ADDRESS: 3628-3644 LINCOLN

APPLICATION NO: #HDC-2024-00388

HISTORIC DISTRICT: WOODBRIDGE FARM

SCOPE: ERECT FENCE AND ALTER LANDSCAPING

3628-3644 Lincoln, aerial view which depicts the proposed fencing. Submitted by applicant

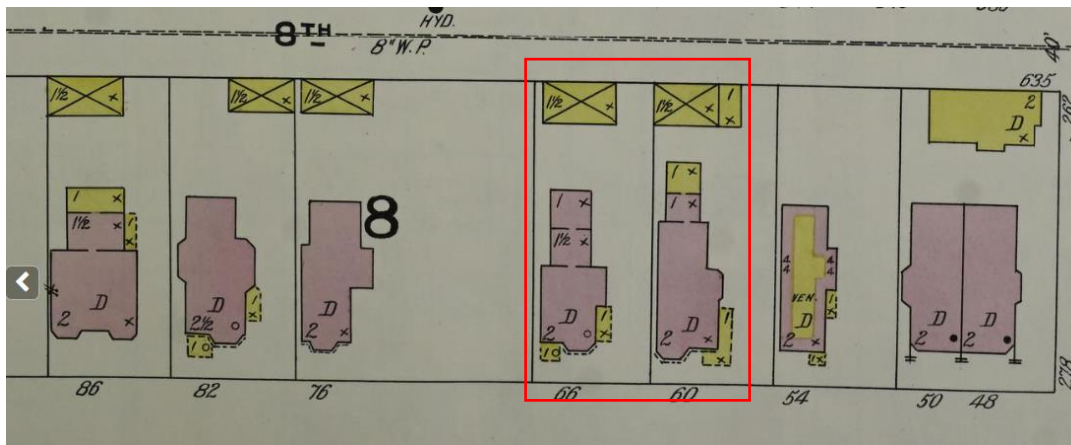
- At the rear/east property line, erect a wood (cedar) privacy fence with rolling gate. Note that the drawing indicates that the fence/gate will be 6'-0" tall. However, the applicant has verbally stated that he wishes the fence to measure 7'-0" in height.

- The project’s architectural drawings note that the rear wood fencing/gate will be 6’-0” in height. However, the applicant has noted that the height as indicated in the drawing is incorrect and that he desires for the fence at this location to rise to 7’-0” in height. Staff finds the proposed 7’-0” height and material to be appropriate with the condition that it be painted or stained an appropriate color within a year of its erection.

- The project's architectural drawings shall be revised to note that the rear wood fencing/gate will be 7'-0" in height prior to the issuance of the project's permit. Also, the wood fencing proposed for installation at the rear property line shall be painted or stained an appropriate color within a year of its erection. HDC staff shall be afforded the opportunity to review and approve the final color choice prior to the issuance of the project's permit.

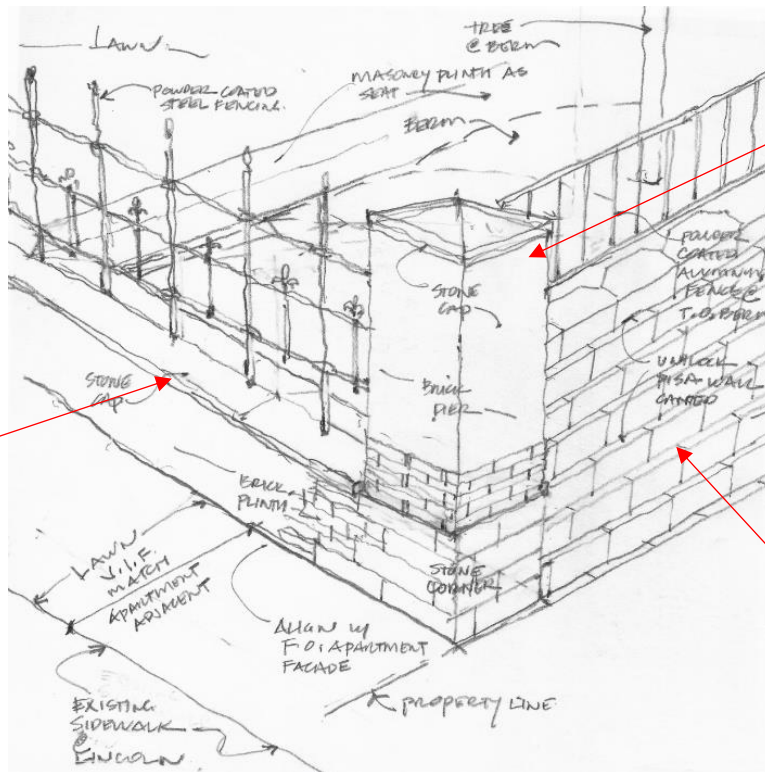
- Regarding the pier which is proposed for the property's southwest corner, note that the front yard fencing at this location will be 5'-6" in height at its intersection with the pier while the side yard fencing will be 7'-0" in height at its intersection with the pier. As the current application does not indicate the height or the footprint dimensions of the pier at this location (see the below image), it is unclear to staff how the transition between the side and front yard fencing will be executed. It is staff's opinion that the pier's height should be high enough to meet the 7'-0" height of the side wall/fence.

The height of the corner pier is not indicated in the drawing nor are the dimensions of its footprint. Also, a graphic detailing how the front fencing and the side wall/fence will actually interact with the corner pier has not yet been provided

This wall with fence mounted atop will measure 7'-0" in height and will be 1'-8" deep

This fencing is proposed for the front property line and will be 5'-6" in height, 1'-7 1/4 in width, and will be set back nearly 3' from the sidewalk

Drawing of pier proposed for southwest corner of lot. Note that the height of the pier is not indicated. The applicant has noted that they have yet to determine that detail. It is staff's opinion that it should be high enough to meet the 7'-0" height of the side wall/fence.

- Re: the pier that is proposed for the property's southwest corner, the applicant shall submit a drawing to staff which specifies its height and footprint dimensions and details the transition between the side and front yard fencing. Staff shall be afforded the opportunity to approve this element prior to the issuance of the project permit.

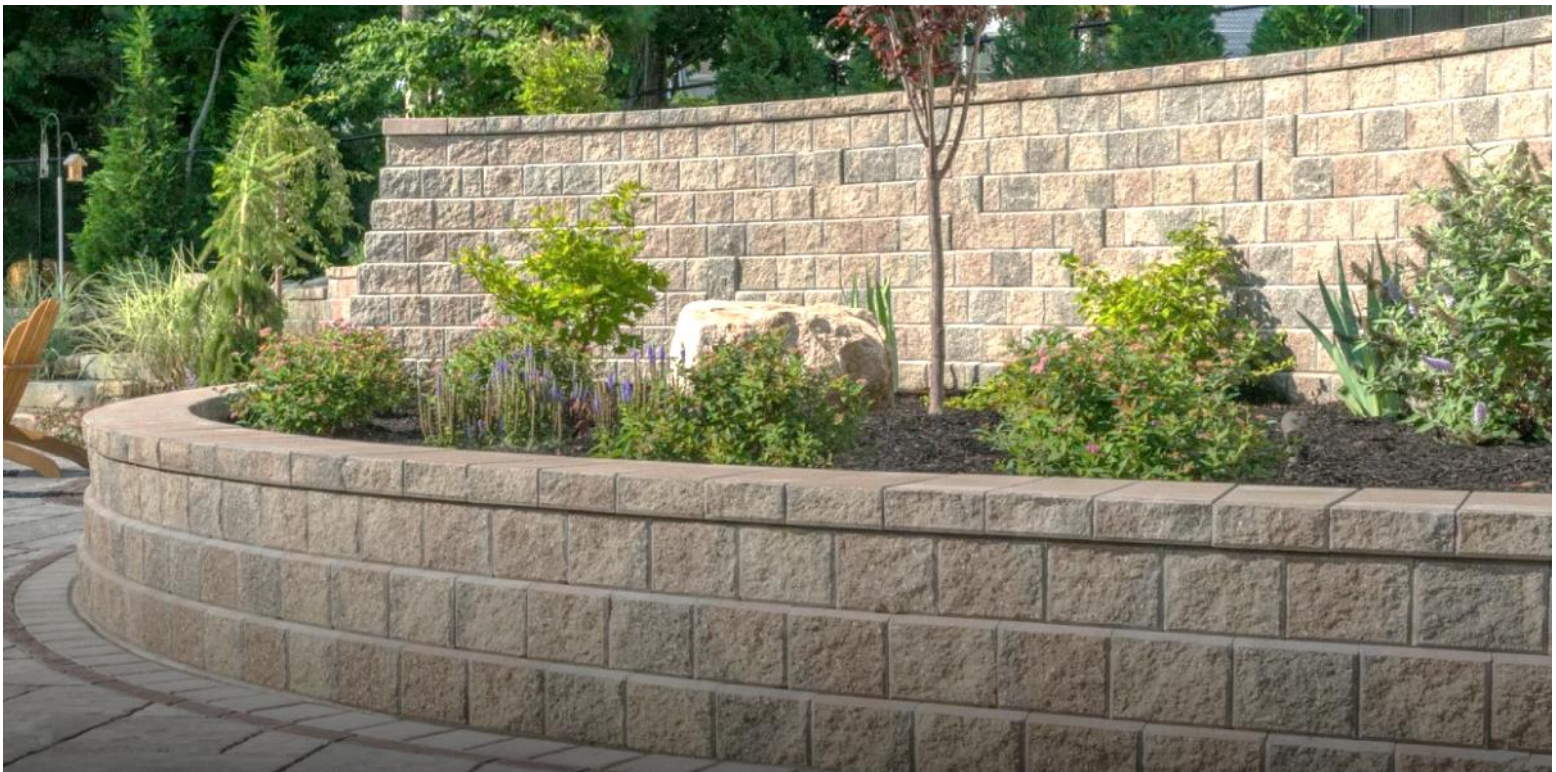
- Regarding the Unilock masonry product proposed for the south retaining wall, note that it will be highly visible from the public right of way when viewing the property/historic district facing north and/or east from Brainard and Lincoln. Please see the submitted brochure for the product and the below image to note that it is essentially concrete block which is manufactured to approximate the esthetic of natural stone. It is staff's opinion that the product does a poor job of approximating traditional stone for the following reasons:

- The product presents a regular, machined appearance versus the irregular and naturally varied appearance that natural stone offers
 - The product will be dry stacked and does not have mortar joints, which natural stone typically has

- The product's rough textured surface/finish does not have the same depth as traditional stone

It is staff's opinion that the proposed Unilock product, which is commonly used as a decorative landscaping element within contemporary suburban residential and commercial settings, is incompatible with the historic character of the late 19th and early 20th century domestic properties along Lincon Street. It is also staff's opinion that the highly visible wall will present a stark, incompatible machined/modern appearance when viewed within the context of the property's historic masonry/brick and natural stone and the brick and natural stone products proposed for the new fencing and pier at the front property line. It is staff's opinion that a simple masonry wall which is faced with brick, a painted concrete wall or painted concrete block wall (topped with the proposed aluminum fencing to mark the element as a recent addition) which sits quietly within its setting would be a more appropriate esthetic treatment for the proposed retaining wall.

- The proposed Unilock masonry product shall not be utilized for the retaining wall as it will be highly visible and will present an appearance that is incompatible with the historic character of the property and the historic district. Rather, the applicant shall select a product which better reflects the qualities of/is visually compatible with the features, texture, and color with the historic masonry found throughout the neighborhood. Staff shall be afforded the opportunity to review and approve the final project selection prior to the issuance of the project permit.
